**CULTURAL RESOURCES OFFICE
PRESERVATION BOARD
REGULAR MEETING
MONDAY – OCTOBER 26, 2015 — 4:00 P.M.
1520 MARKET ST. #2000
ST. LOUIS, MO. 63103
www.stlouis-mo.gov/cultural-resources**

DATE: October 26, 2015
ADDRESS: 4172 Blaine Avenue
ITEM: New construction: construct one two-story, single-family house
JURISDICTION: North I-44 Certified Local Historic District — Ward 19
STAFF: Jan Cameron, Cultural Resources Office

DATE: October 26, 2015
ADDRESS: 4490 and 4494 Lindell Boulevard
ITEM: Preliminary Review to rehabilitate two office buildings
JURISDICTION: Central West End Certified Local Historic District — Ward 17
STAFF: Betsy Bradley, Director, Cultural Resources Office

FRONT ELEVATION

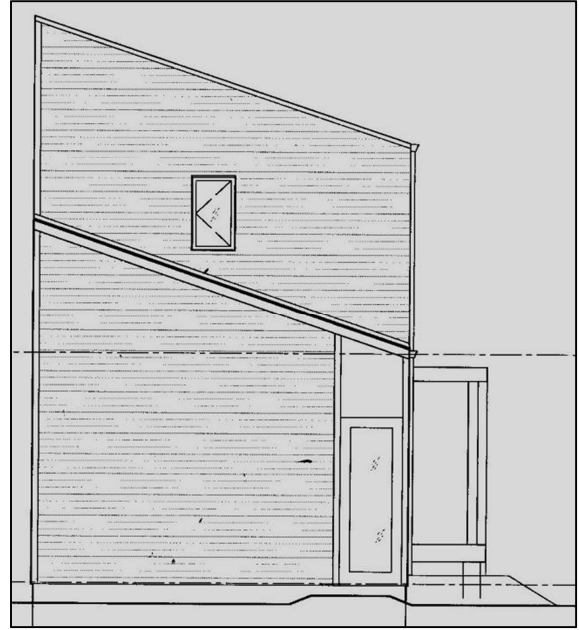
Does not comply. The proposed design purposely avoids architectural details such as sills and lintels that are typical of historic buildings. It follows a contemporary vocabulary already present in other new buildings, but retains the appearance of punched openings and in most instances, the proportions and vertical orientation of historic double-hung sash.

Does not comply. While the material of the proposed windows is compliant, color-finished aluminum-clad wood, the fenestration pattern of the front façade is asymmetrical: windows differ in size, function and placement. Neither the fenestration pattern nor the sizes of the windows is comparable to windows in the historic residences in the district. As this building will not have a front porch, this unusual asymmetry will be particularly evident.

Does not comply. Flat roofs predominate on the block. The shed roof of the proposed building façade continues the “flounder” shape recently approved by the Preservation Board for a multi-unit development under construction further east on Blaine, which combines 2-story houses and 1-story “flounder” designs.

Based on the preliminary findings, the Cultural Resources Office recommends that the Preservation Board grant preliminary approval to the proposed design, with the condition that proportions and size of the front windows be revised, and the pattern of cement panels be simplified and regularized to bring the project into compliance with the historic district standards, and that final plans, exterior materials and colors be reviewed and approved by the Cultural Resources Office.

EAST ELEVATION

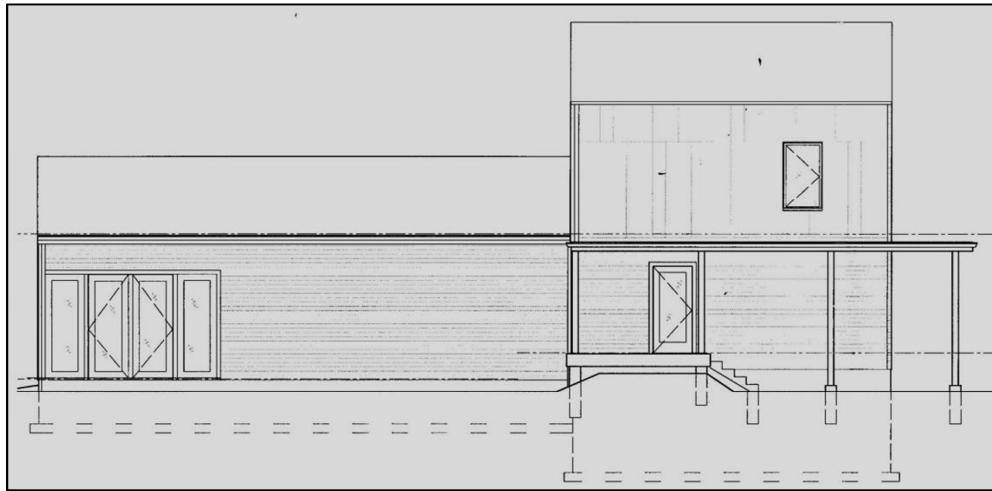
The proposed cement siding does not comply with the standards, which limit the use of wood or replica wood to decorative trim and appendages. Lap siding with a

four-inch reveal will clad most of the first story of each side elevation. Siding has been approved in similar locations on other new buildings in the district.

Houses are intended to be constructed on the parcels to the west of the project site; but because of the wide side yard, the eastern façade will be permanently exposed to street view. The second story of the east façade and both first and second story of the west, will be sheathed in flat panels of cementboard, of varied sizes and arranged in irregular patterns. This treatment diminishes the appearance of a flat surface and runs counter to the consistency recommended by the standards.

LINDELL BOULEVARD FAÇADE OF PAVILION

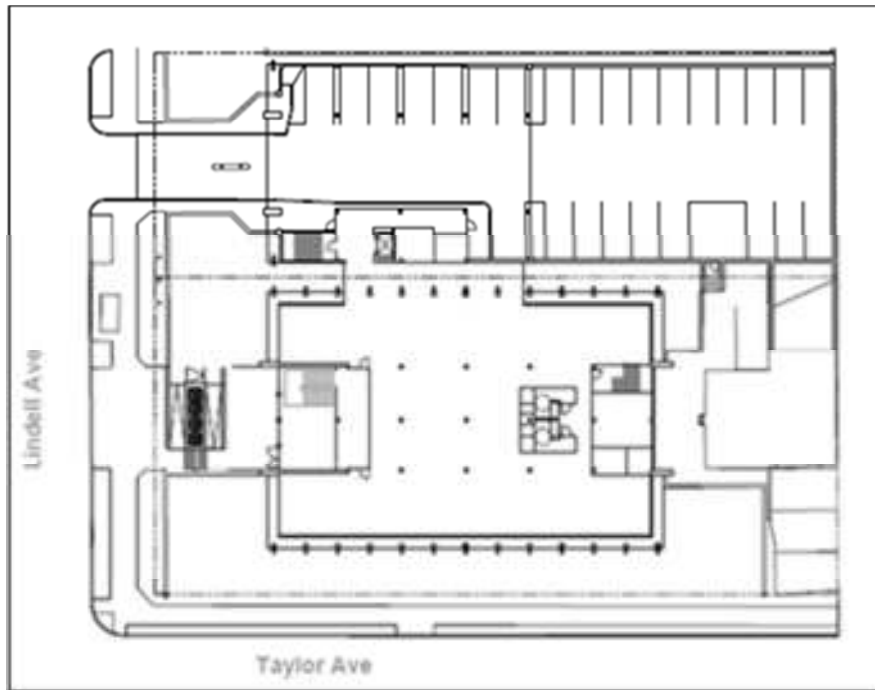
- This proposal does not meet the intent of the historic district standards for maintaining the historic materials and character of the exterior walls and windows.

- The travertine tile exterior of the walls of the pavilion is applied directly to material behind it in an atypical construction method. The applicant's architect describes it as a "tiled interior partition wall" placed to perform as a "mass wall."

- The creation of an accessible main entrance is proposed by excavating down to provide an at-grade main entrance into the lower story in the Lindell façade.

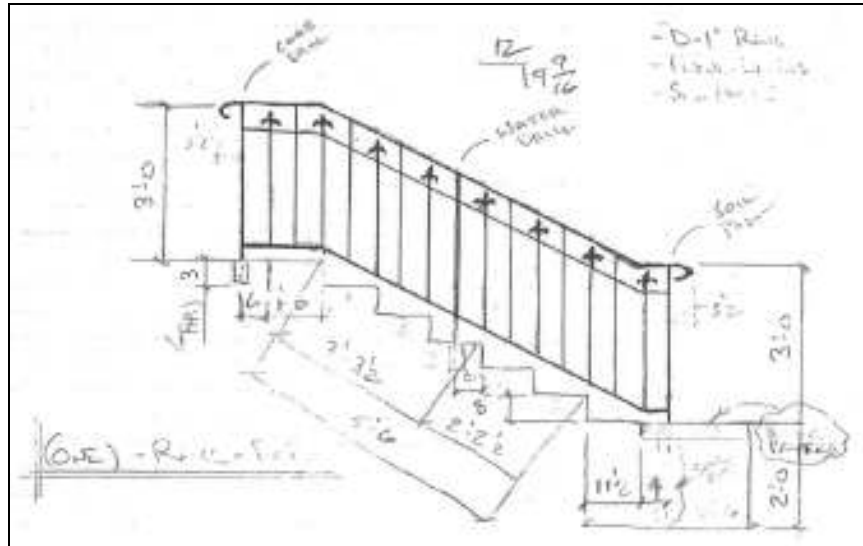
Does not comply. Proposed handrail is based on a fence design, not an appropriate historic handrail design.

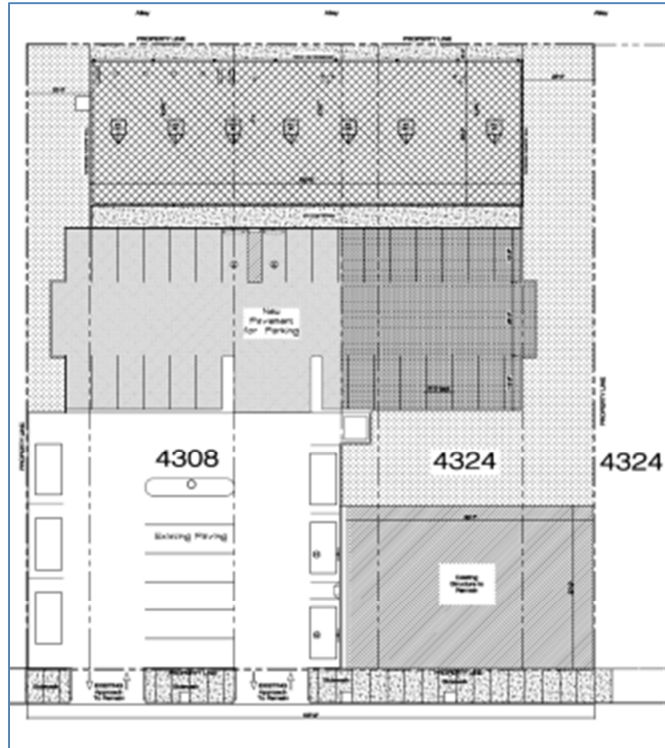
Complies. The majority of the buildings on the block have flat roofs.

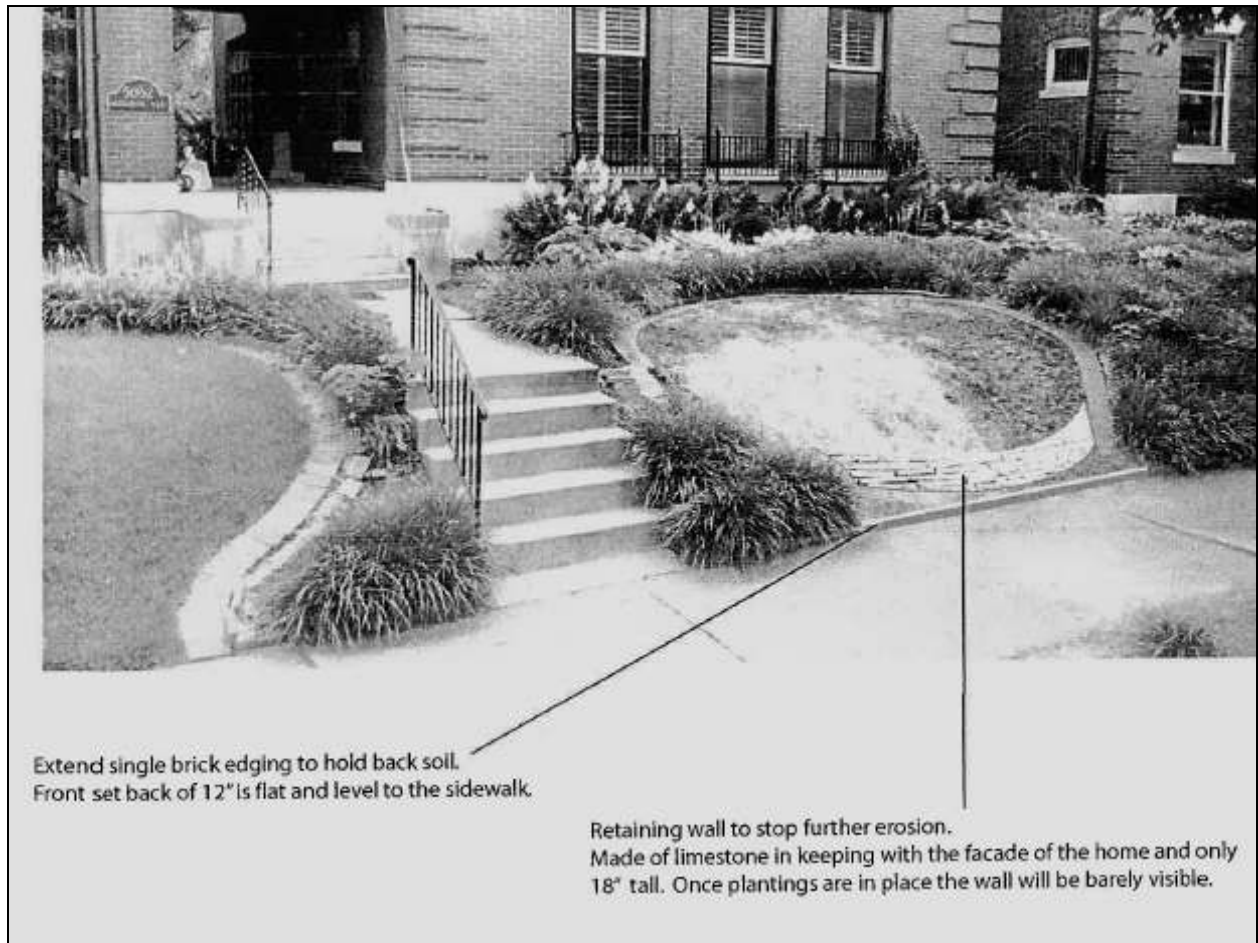
Does not comply. The proposed project would alter the original terrace. The terrace has been excavated but additional work stopped when a neighbor confronted the owner regarding required permits.

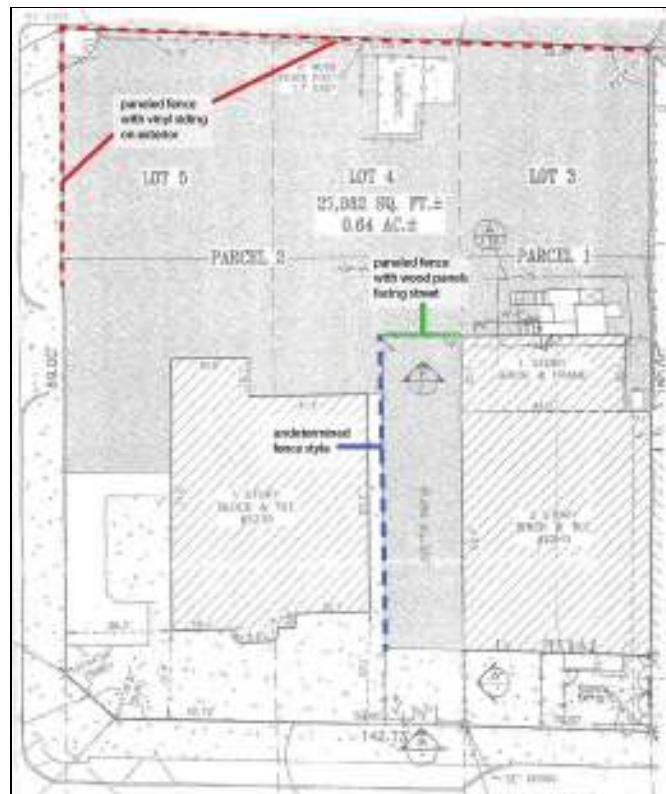
Does not comply. The proposed fence is of a contemporary design which is not compatible with the character of the neighborhood. The exterior of the fence, exposed to street view, will be primarily vinyl lap siding, which is not an approved material for fences in the neighborhood. Some of the fence materials proposed to be used and the graphic elements are unclear on the submitted plans. The fence is proposed to be 10 feet in height which is 4 feet above the maximum fence height in the standards.
